**Before the
Federal Communications Commission
Washington, D.C. 20554**

**COMMENTS OF THE
NATIONAL ASSOCIATION OF BROADCASTERS, ABC TELEVISION AFFILIATES
ASSOCIATION, FBC TELEVISION AFFILIATES ASSOCIATION, CBS TELEVISION
NETWORK AFFILIATES ASSOCIATION, NBC TELEVISION AFFILIATES, THE
ASSOCIATION OF PUBLIC TELEVISION STATIONS, THE CORPORATION FOR
PUBLIC BROADCASTING, AND THE PUBLIC BROADCASTING SERVICE**

March 18, 2014

Figure 1.

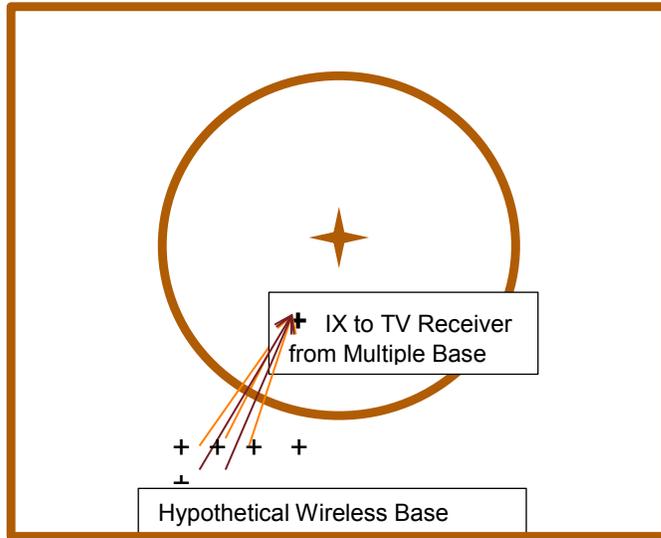
In reality, wireless providers are likely to have a large number of cell sites in close proximity operating over a wide area with high traffic volumes at multiple base stations at the same time. Transmissions from multiple base stations can combine and cause interference to DTV service, even in cases where a single wireless signal may not cause interference.

proposed OET methodology, a DTV receiver receiving a 65 dB μ DTV signal and two 50 dB μ interfering signals from two proximate co-channel wireless sites would be deemed to have no interference since each wireless base station would meet the 15 dB D/U ratio (for each transmitter, $D/U = 65 \text{ dB}\mu - 50 \text{ dB}\mu = +15 \text{ dB}$). However, these interfering signals will have an additive effect and create interference when combined. Using the RSS method, the two 50 dB μ signals would yield an interfering signal of 70 dB μ and result in a D/U ratio at the RTV receiver of -5 dB rather than +15 dB ($D/U = 65 \text{ dB}\mu - 70 \text{ dB}\mu = -5\text{dB}$).

As the Commission already found with multiple DTS transmitters, the combined interference effect of multiple transmitters needs to be taken into account and “the RSS method in virtually all situations will best approximate actual interference” from multiple transmitters to DTV signals.⁴¹ Failure to consider the combined interference effect of multiple wireless base stations will result in increased interference to DTV stations. The Commission has a statutory responsibility to protect broadcasting and DTV viewers and cannot ignore “real world” interference from multiple wireless operations; thus, any methodology used to predict potential inter-service interference should take this into account. The Joint Broadcasters urge the Commission to consider interference from multiple wireless base stations using either a simple direct summation method or the RSS method utilized for calculating interference from multiple DTS transmitters under the current rules.

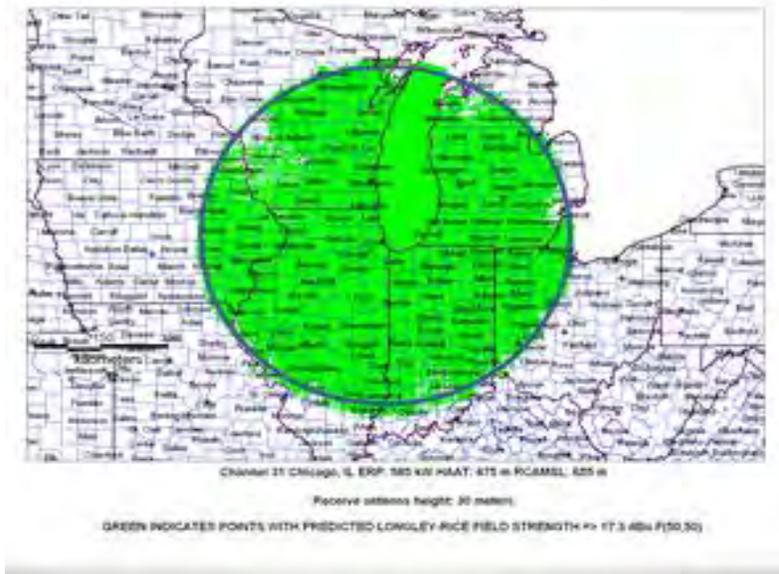
The following plot was shown at the Commission’s February 21 LEARN Workshop regarding the proposed OET methodology. The plot represents the potential for interference from a DTV station to a wireless base station. The station used in this plot is a DTV station in Johnstown, Pennsylvania. Presumably, this DTV station was selected because the irregular terrain in this part of the country would emphasize the difference between using the proposed OET methodology and a simple separation distance or contour. However, *even in this highly irregular terrain*, the practical difference between methods is minimal with respect to spectral efficiency. The contour was added to the LEARN Workshop slide to show what a typical separation distance or contour approach would look like.

To the extent that certain “white spaces” are present within the contour, these generally represent mountain ranges with little or no population to be served. They certainly do not represent areas where widespread wireless deployment is possible or would be anticipated.

These two examples suggest that a straightforward contour calculation does not produce meaningful inefficiencies as compared to the unduly complex and computationally intensive OET methodology. Contrary to OET’s assertions, a separation distance approach is not spectrally inefficient in any meaningful sense, and the proposed methodology will not produce significant additional spectrum. The proposed OET methodology should be abandoned and replaced with a simple contour separation distance approach, discussed in Section VI below. The Joint Broadcasters also believe that providing wireless bidders with simple information such as actual separation distances to co- and adjacent-channel DTV stations is significantly more meaningful than providing bidders with misinformation regarding “impaired” or “restricted” areas based on complex calculations that use erroneous assumptions and assume unlikely hypothetical base station locations.
